Department of Property & Procurement

July 14, 2020

AMENDMENT #1- IFB041DOET20 (C)– Qualified contractors to furnish all labor, tools, equipment, and supplies necessary for the **Construction of the Roof at the Charlotte Amalie High School, Buildings 29 and 30 on the island of St. Thomas, Virgin Islands.**

Questions and Answers

SHEET NO.: **A1**

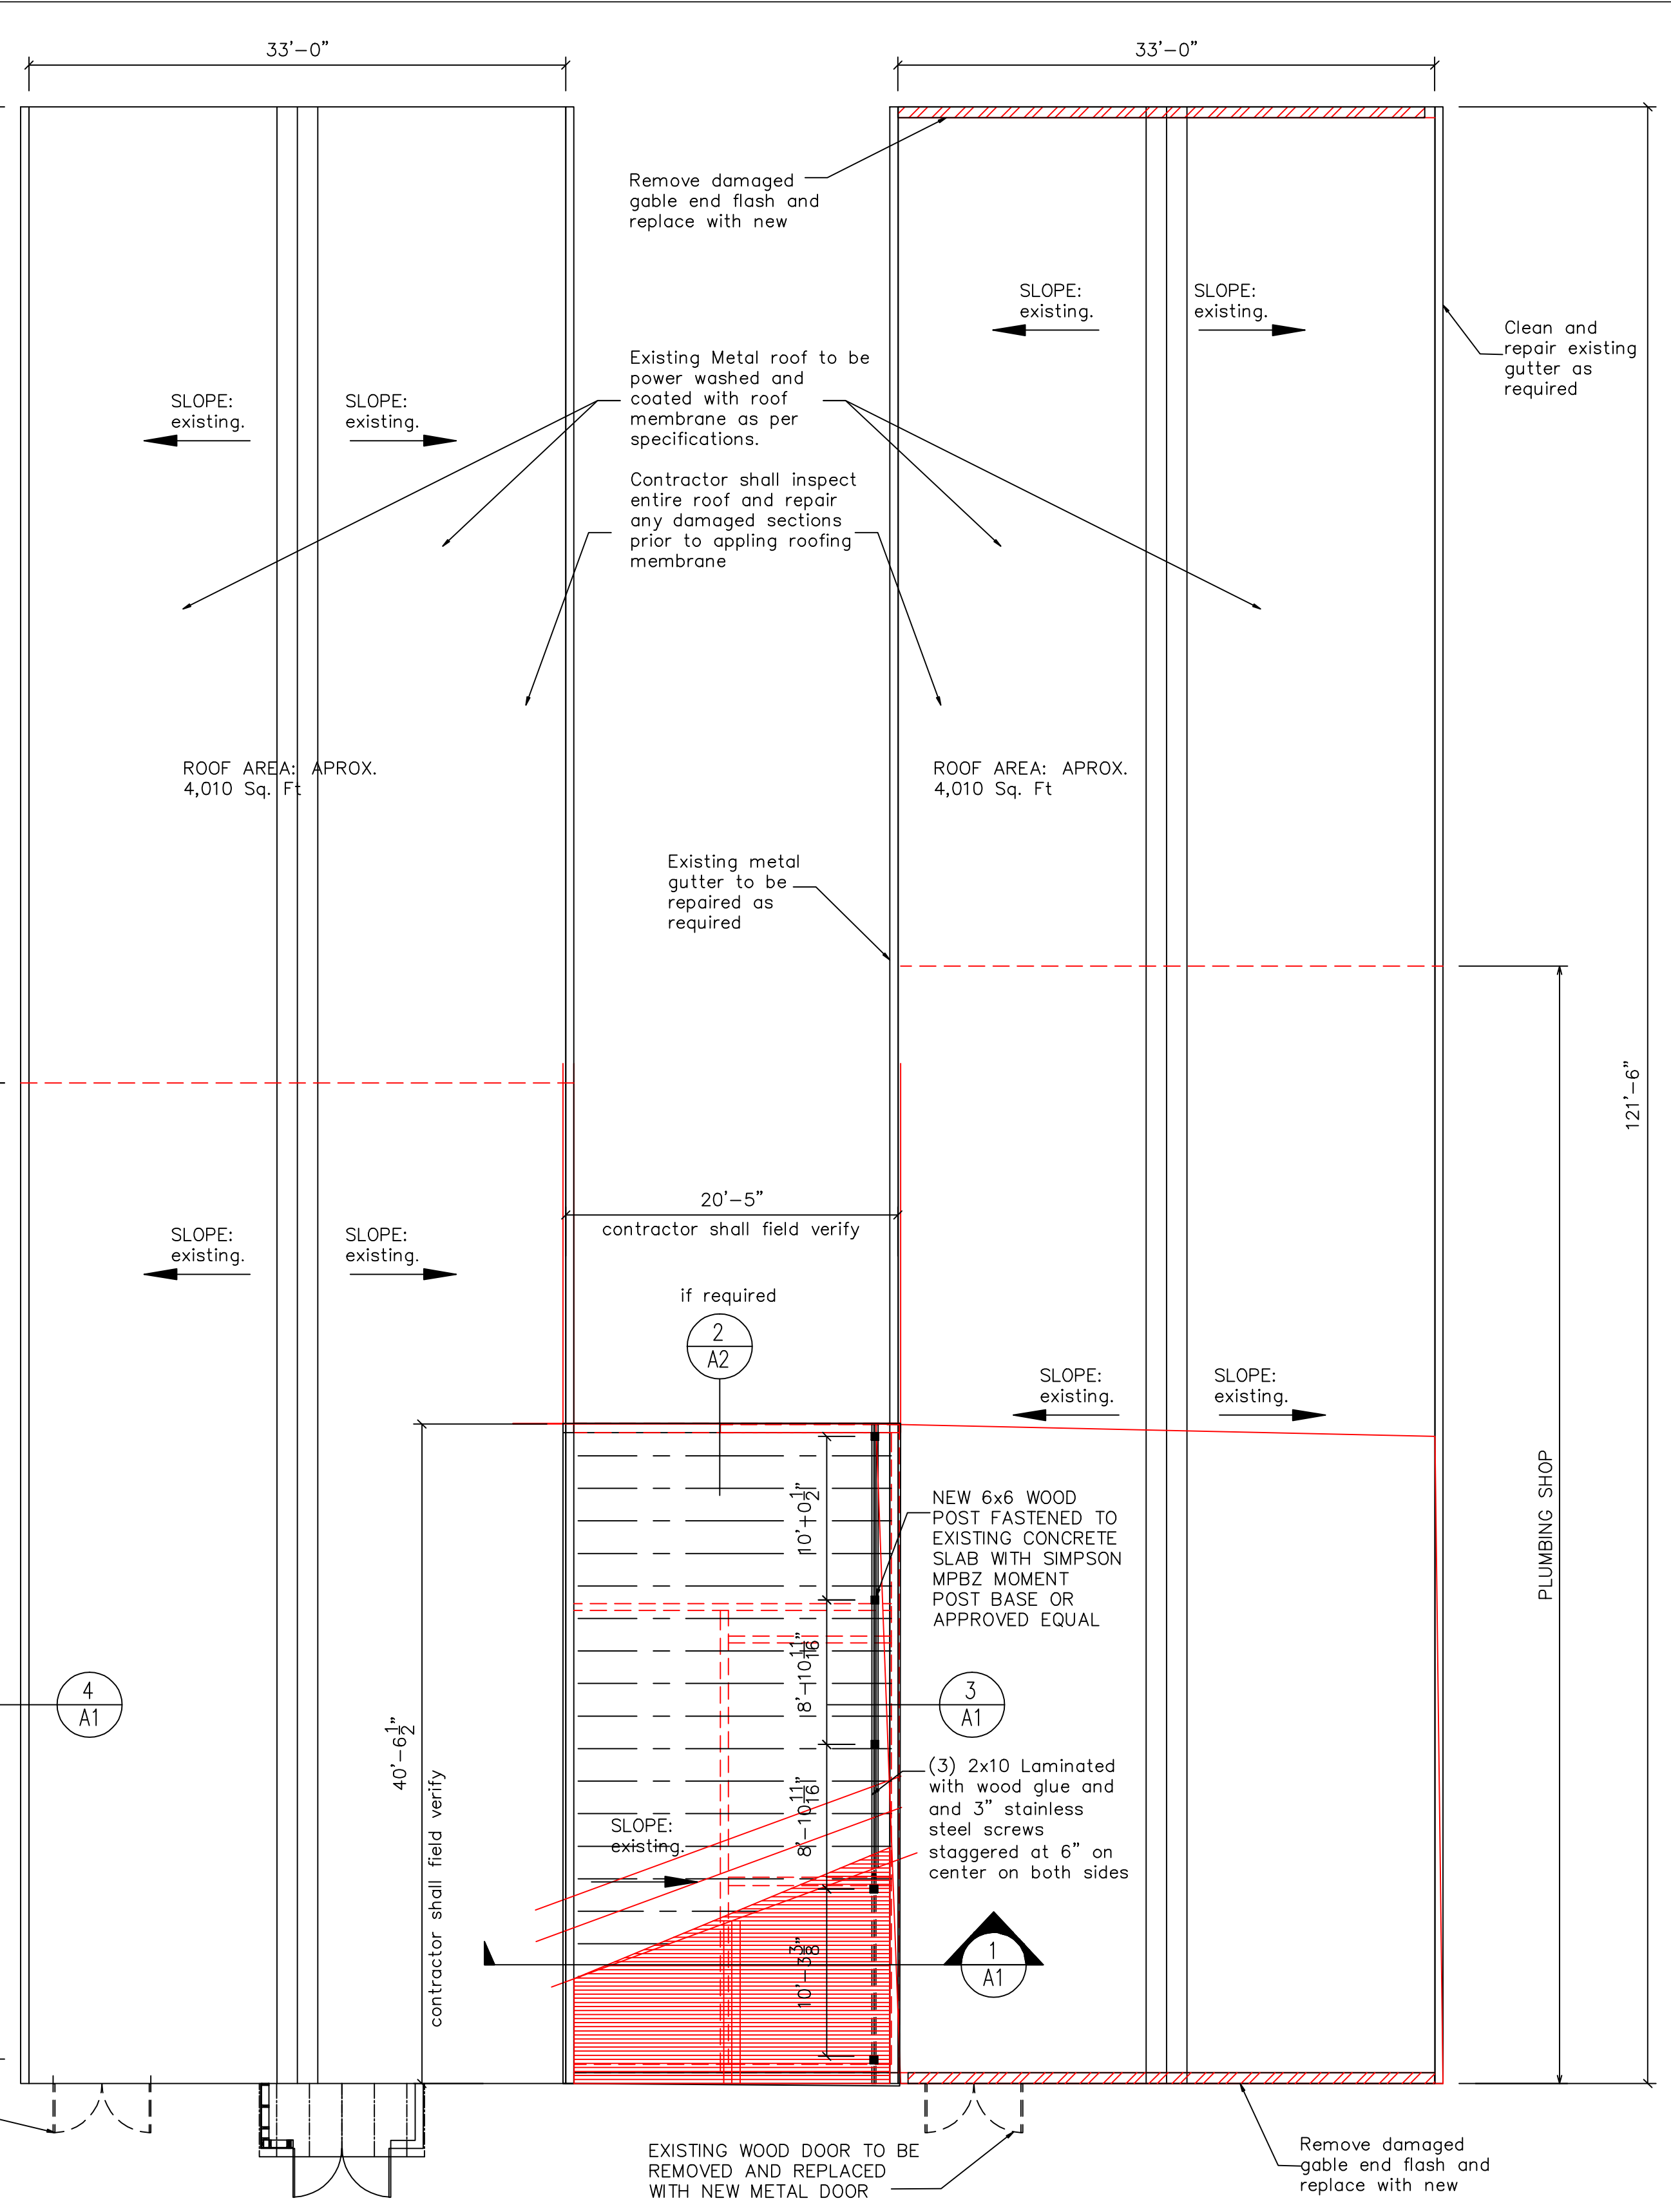
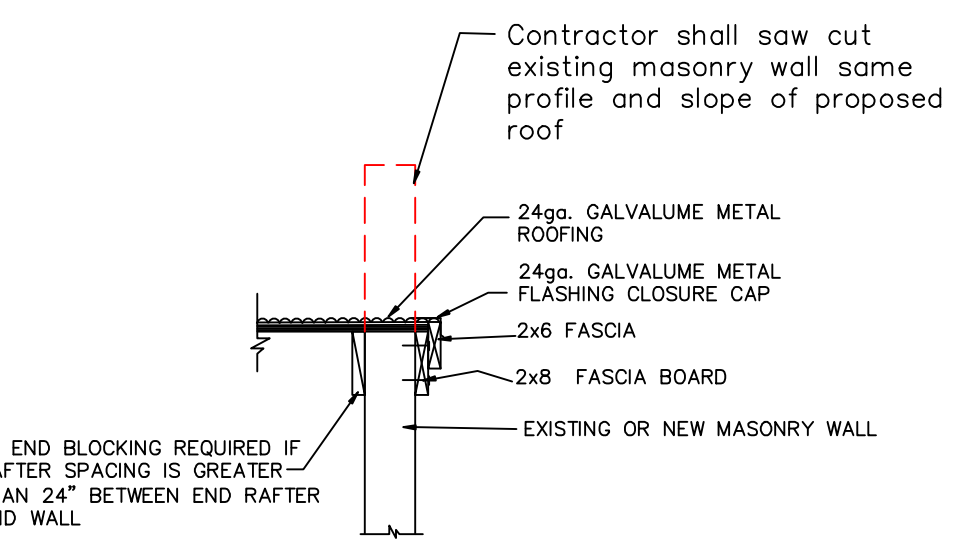
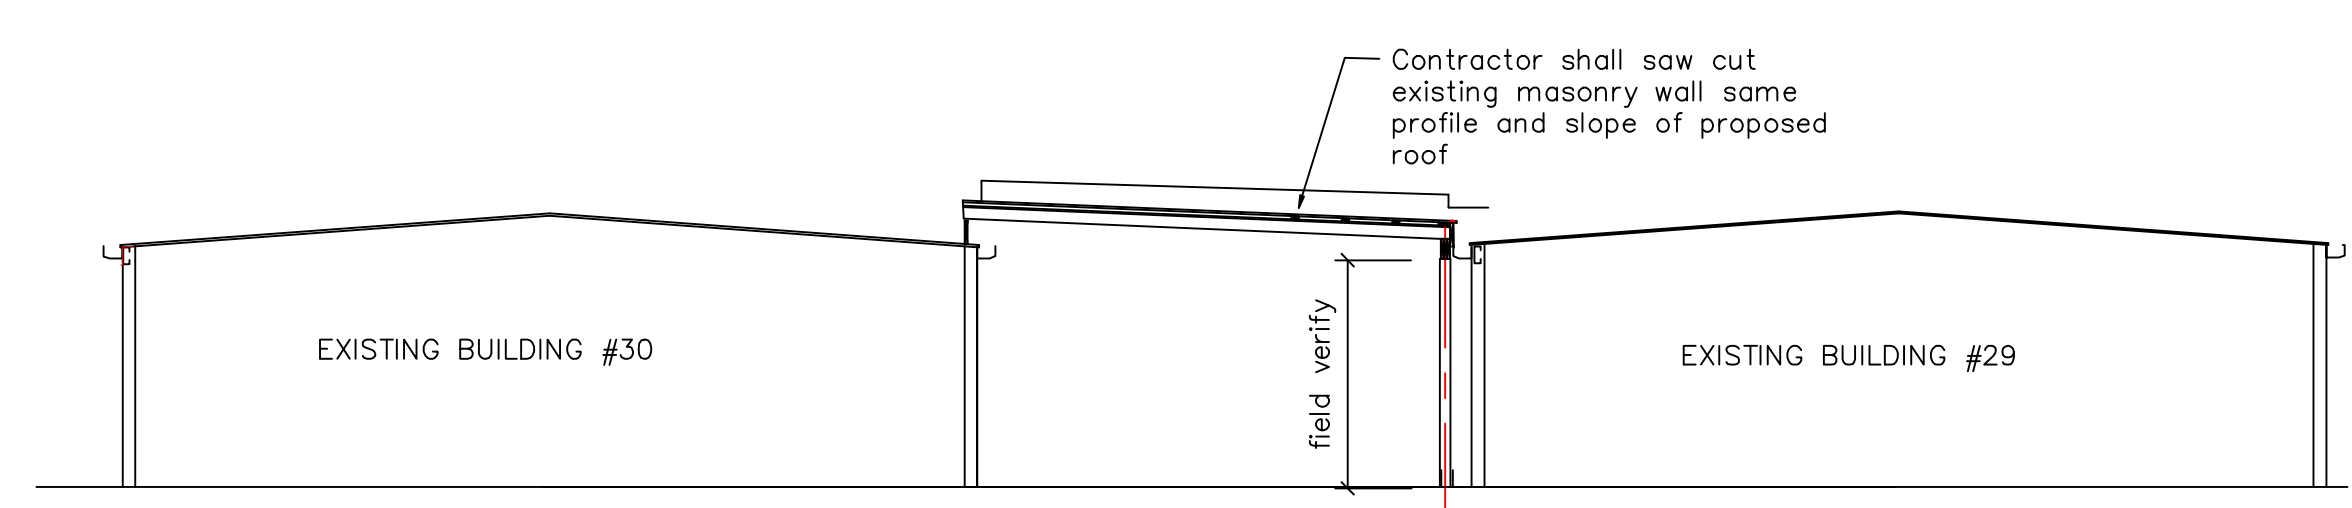
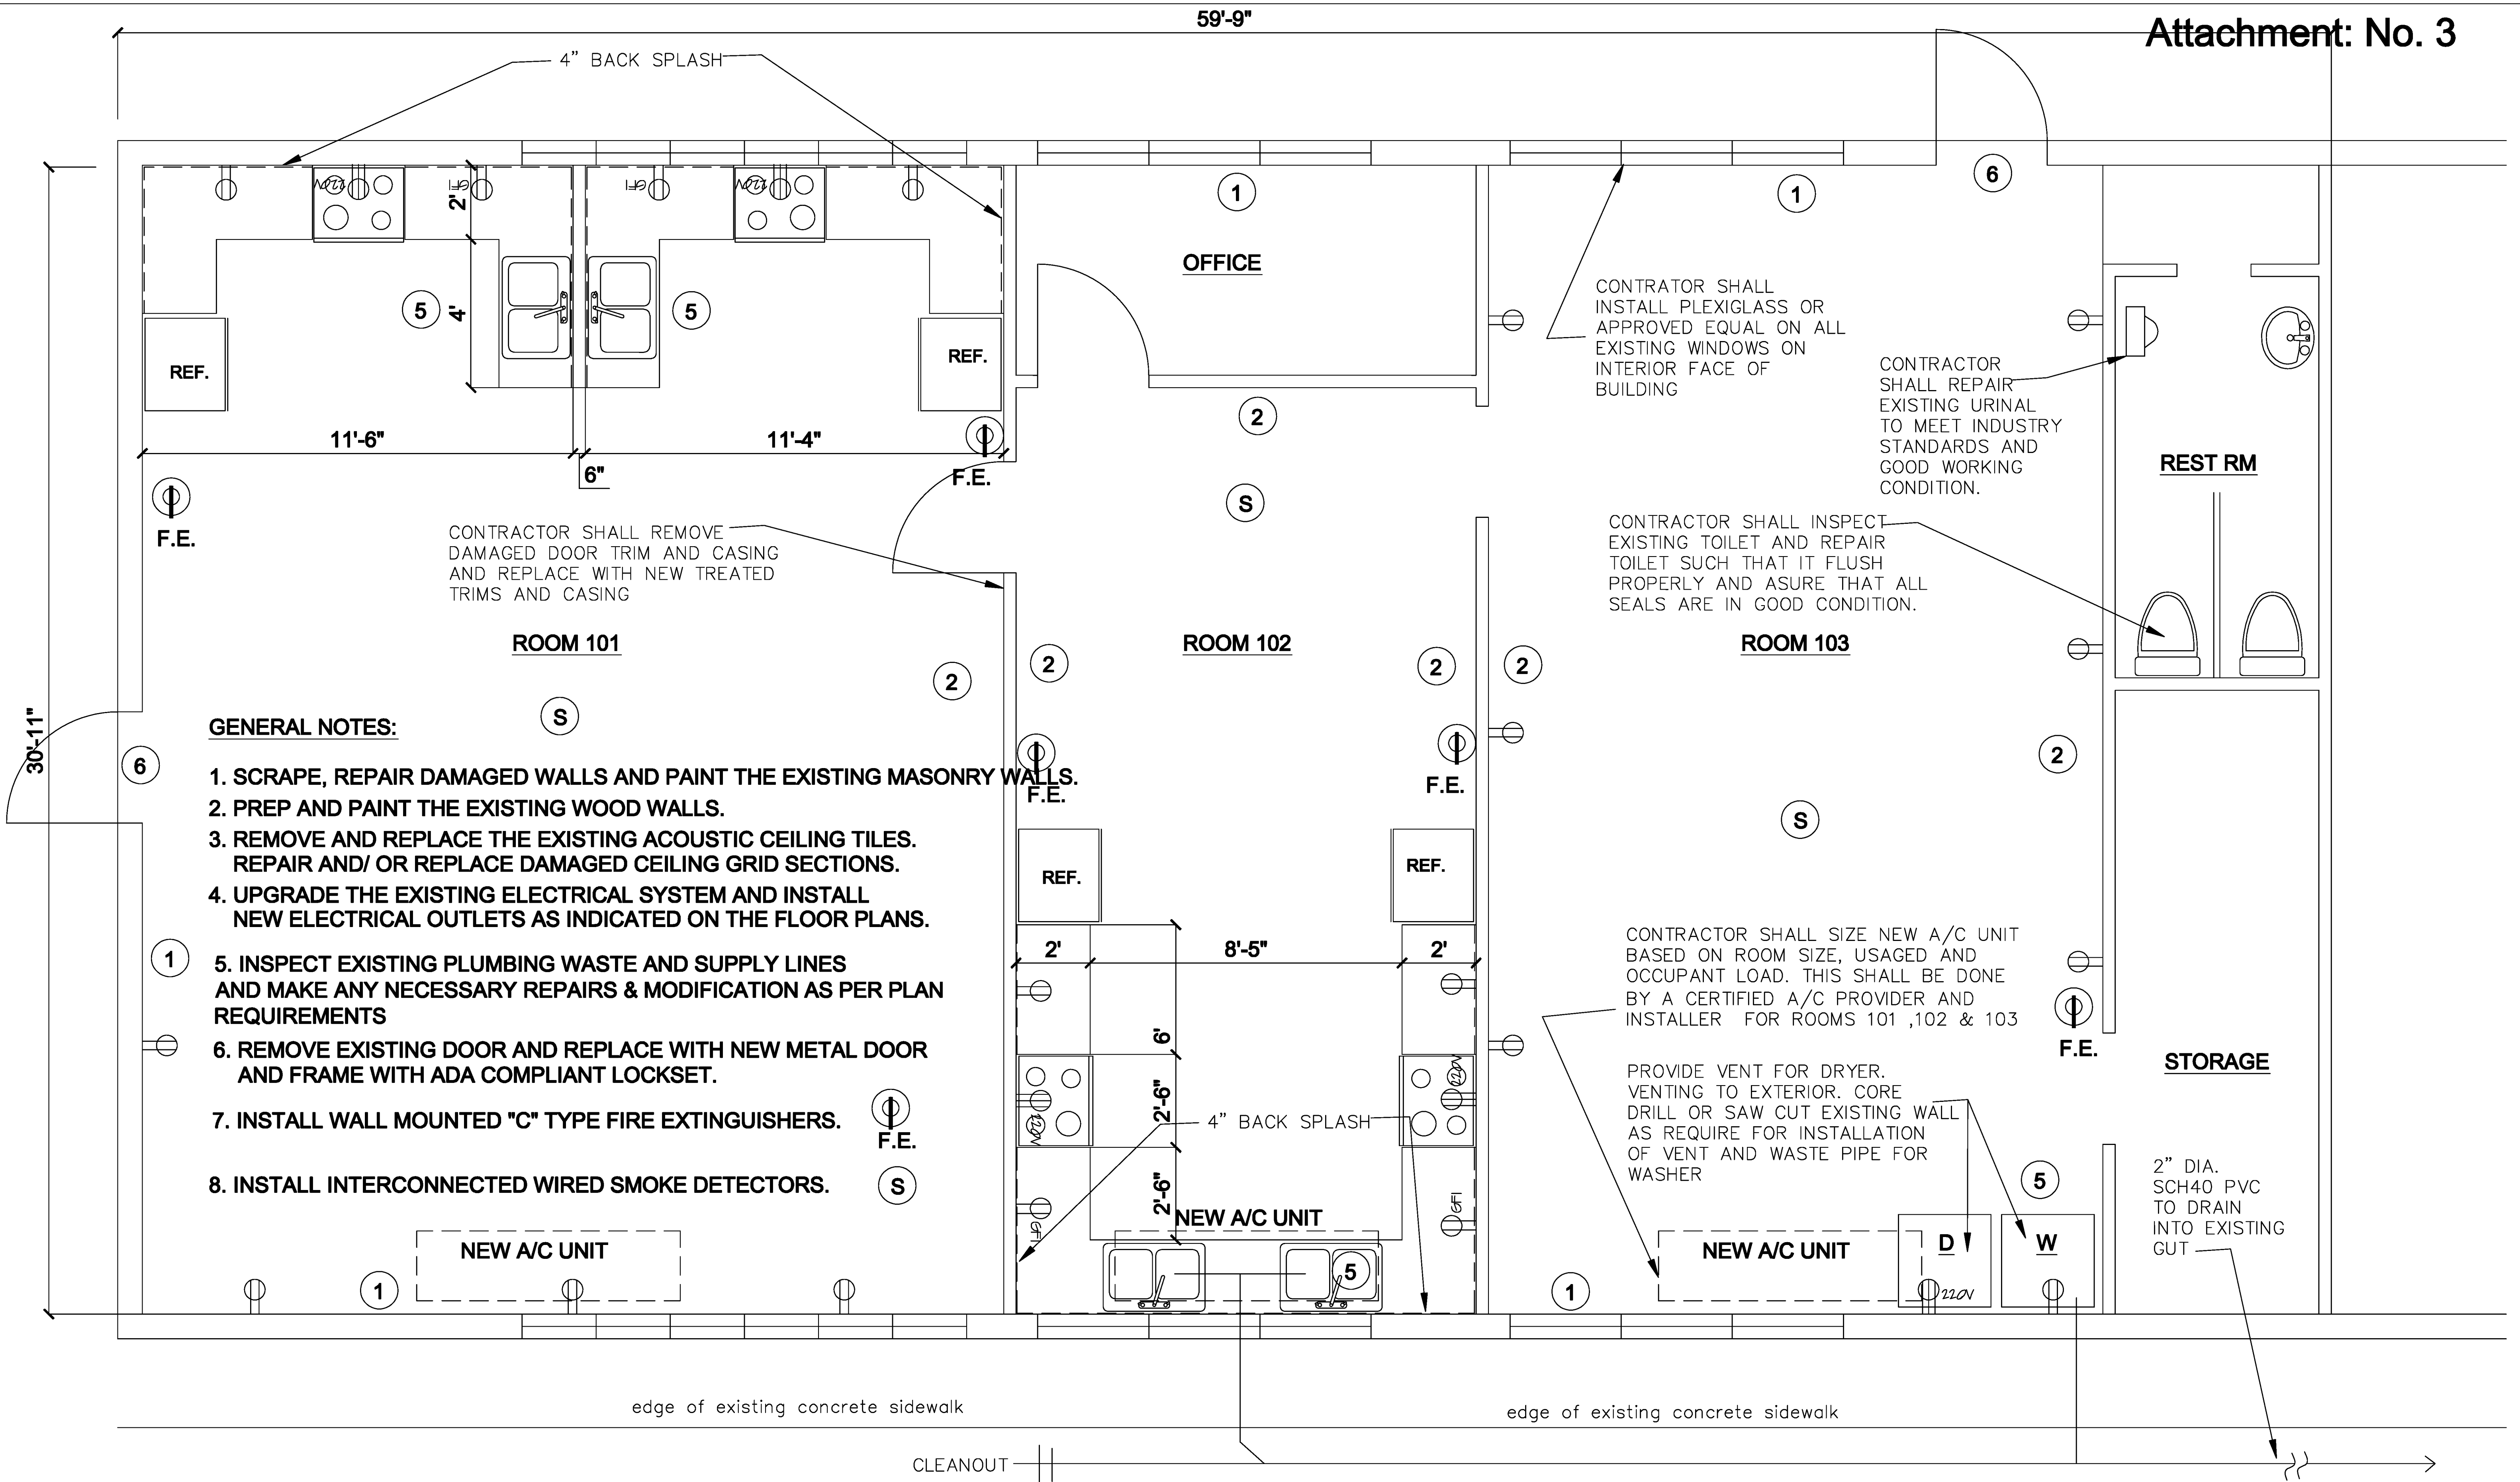
8. Question: Line Item #13.05- Provide Attachment 3 Sheet A- 2

10. Question: Line Item #13.07- Provide Attachment 3 Sheet A- 2

11. Question: Line Item #13.08- Provide Attachment 3 Sheet A-2

Response: Please see attached.

Response: See attached.

Response: See attached.

DRAWING TITLE
TYPICAL CONCRETE AND MASONRY REPAIRS

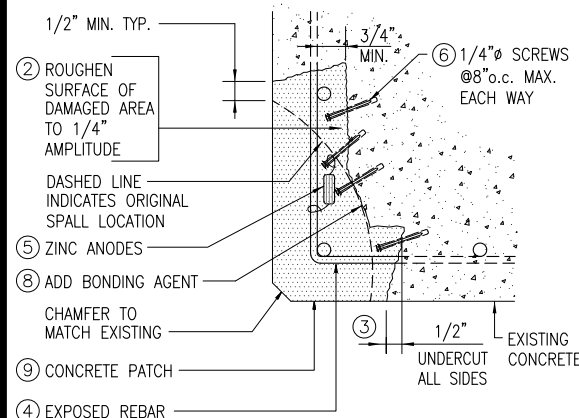
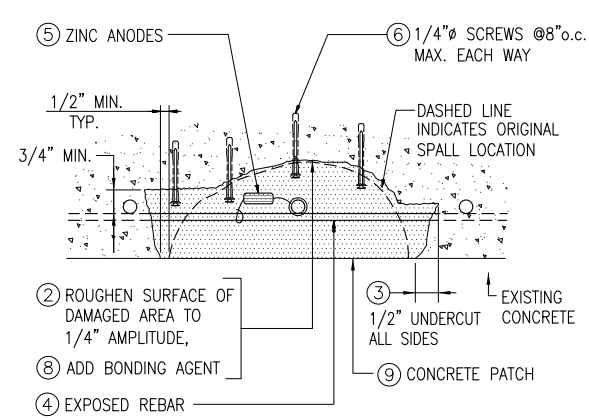
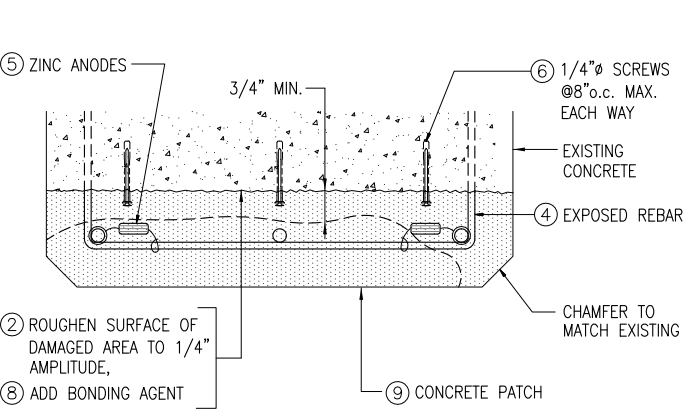
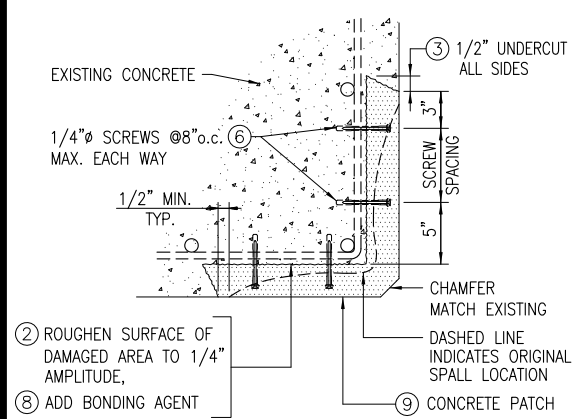
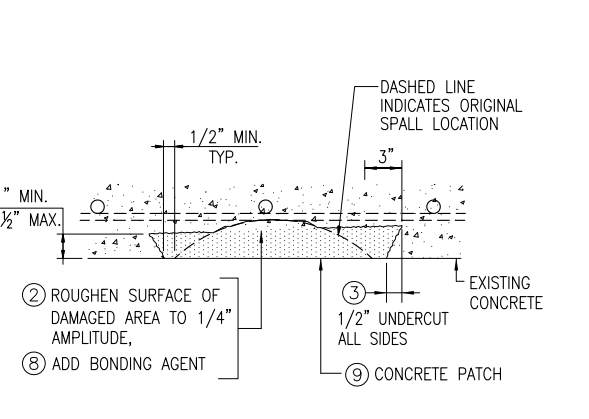
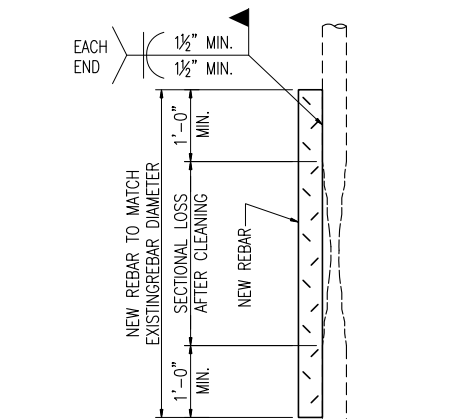
21. Question: Line Item #17.08- Provide Attachment 4-Typical Spall Repair Details

Response: See attached
